**U.S. DEPARTMENT OF ENERGY (DOE) REVIEW OF U.S. NUCLEAR REGULATORY COMMISSION'S (NRC) REPOSITORY DESIGN AND THERMAL-MECHANICAL EFFECTS ISSUE RESOLUTION STATUS REPORT, REVISION 2**

Enclosure:  
Comments on Issue Resolution Status Report,  
Revision 2 Key Technical Issue: Repository  
Design and Thermal-Mechanical Effects

**COMMENTS ON ISSUE RESOLUTION STATUS REPORT,  
REVISION 2, KEY TECHNICAL ISSUE: REPOSITORY  
DESIGN AND THERMAL-MECHANICAL EFFECTS**

Figure 1. Shear Strength Curve Based on the Hoek and Brown (1997) Approach (GSI=62,  $\sigma_{ci}$ =167.9 MPa,  $m_i$ =19.68)

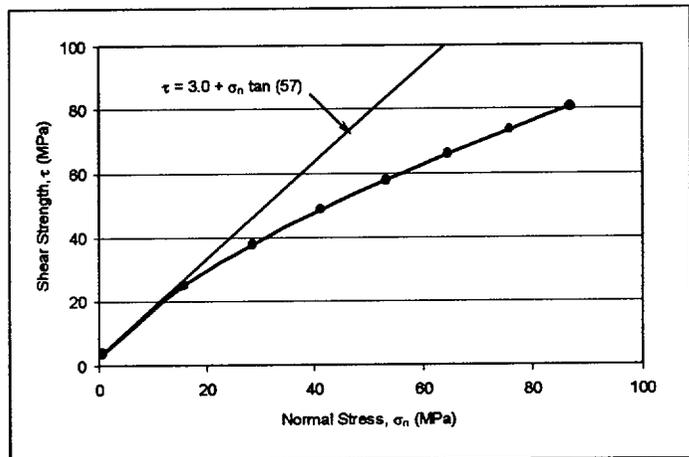
3. Section 4.3.3.2, Page 31, Paragraphs 2 and 3: The IRSR states that the rock mass friction angles predicted by DOE in *Confirmation of Empirical Design Methodologies* (IRSR Reference CRWMS M&O 1997a) are 57° and 58° . It notes an apparent conflict with the values predicted by NRC (28° to 35°) based on the method described in *Practical Estimates of Rock Mass Strength* (IRSR Reference Hoek and Brown 1997).

DOE believes that its approach is consistent with the reference cited by the NRC and that the apparent discrepancy is due to the range of the confining pressures used for the curve-fit of the non-linear Hoek and Brown curve to the linear Mohr-Coulomb criterion. The source referenced by the NRC, *Practical Estimates of Rock Mass Strength* (IRSR Reference Hoek and Brown 1997), correctly identifies that “...for values of  $\sigma'_n$  of less than 5 MPa, the straight line, constant  $C'$  and  $\phi'$  method overestimates the available shear strength of the rock mass by increasingly significant amounts as  $\sigma'_n$  approaches zero. Under such circumstances, it would be prudent to use values of  $C'$  and  $\phi'$  based on the tangent to the shear strength curve in the range of  $\sigma'_n$  values applying in practice.” In-situ stresses at Yucca Mountain are relatively low,

in the range 1 to 3 MPa (SNL 1996). Radial stress is zero on the excavation surface and remains small in the vicinity of the excavation profile. The range of confining, or normal stresses, is in the lower non-linear portion of the Mohr-Coulomb failure envelope. DOE utilizes practices recommended by Hoek and Brown 1997, whereby stability analyses typically use a low cohesion and moderately high friction angle.

DOE suggests that utilizing low  $\phi$ , as predicted by the NRC may result in a design that is excessively conservative. DOE believes that using a lower range of normal stress is appropriate (see Figure 1), and friction angles of  $57^\circ$  to  $58^\circ$  are considered more representative of actual conditions observed in the Exploratory Studies Facility and Enhanced Characterization of the Repository Block Cross Drift where the rock mass cohesion of the TSw2 geologic unit is in the range of 1.9 to 3.9 MPa. Figure 1, below, identifies a single tangent point or solution for the low stress range of  $\sigma_1 - \text{vs} - \sigma_3$  values (where  $\sigma_1$  and  $\sigma_3$  are maximum and minimum principal stresses) calculated using the Hoek-Brown failure criterion (e.g., IRSR references Hoek, 1994; Hoek and Brown, 1997). Multiple tangents are used to determine the range of  $c$  and  $\phi$  that best describes the linear fit for this section of the curve. Based on tests conducted on core specimens collected from boreholes along the alignment of the ESF North Ramp and Main Drift, the friction angles ranged from  $46$  to  $58^\circ$  (IRSR reference CRWMS M&O, 1997h, Table 5-32).

Based on the discussion provided above, DOE recommends that the current IRSR narrative discussion (Section 4.3.3.2, Page 31, Paragraphs 2 and 3) be replaced with the following:

The values for the rock-mass strength parameters  $c$  and  $\phi$  currently proposed for YM (CRWMS M&O, 1997a) were estimated by fitting straight lines to sets of  $\sigma_1 - \text{vs} - \sigma_3$  values (where  $\sigma_1$  and  $\sigma_3$  are maximum and minimum principal stresses) calculated using the Hoek-Brown failure criterion (e.g., Hoek, 1994; Hoek and Brown, 1997).

The procedure presented by Hoek and Brown (1997) for estimating  $c$  and  $\phi$  is based on the GSI index. The values of this index can be determined through geologic mapping of the rock mass following guidelines described by Hoek and Brown (1997) or estimated through correlations with  $Q$  or RMR. The values of  $c$  and  $\phi$  obtained using this procedure (Ofoegbu, 1999) with the TSw2 section of the ESF  $Q$  data (Figure 2) are given as functions of  $Q$  in Figure 4. The figure shows  $\phi$  varying from about  $28^\circ$  to about  $35^\circ$  as  $Q$  varies from about 0.73 to about 13.6. These values of  $\phi$  are much smaller than the DOE values presented previously. The difference between the CRWMS M&O (1997a)  $\phi$  values of  $57$ - $58^\circ$  and the values in Figure 4 ( $28$ - $35^\circ$ ) for the same range of  $Q$  values is quite significant in

predicting the mechanical behavior of the rock mass in the vicinity of the proposed waste-emplacements openings (e.g., see the numerical-model results discussed presently).

The practice of using values of  $c$  and  $\phi$  based on the tangent to the shear strength curve in the range of normal stress values is recommended by Hoek and Brown (1997) because of the low normal, or radial stress around the opening. The range of radial stresses around the opening is in the lower non-linear portion of the Mohr-Coulomb failure envelope, where the method of using a constant  $c$  and  $\phi$  from the broader range of normal stresses overestimates the available shear strength of the rock mass at the vicinity of the tunnel opening. Friction angles of 57 to 58° are considered to be more representative of actual conditions observed in the Exploratory Studies Facility and Enhanced Characterization of the Repository Block Cross Drift, where the rock mass cohesion of the TSw2 geologic unit is calculated in the range of 1.9 to 3.9 MPa.
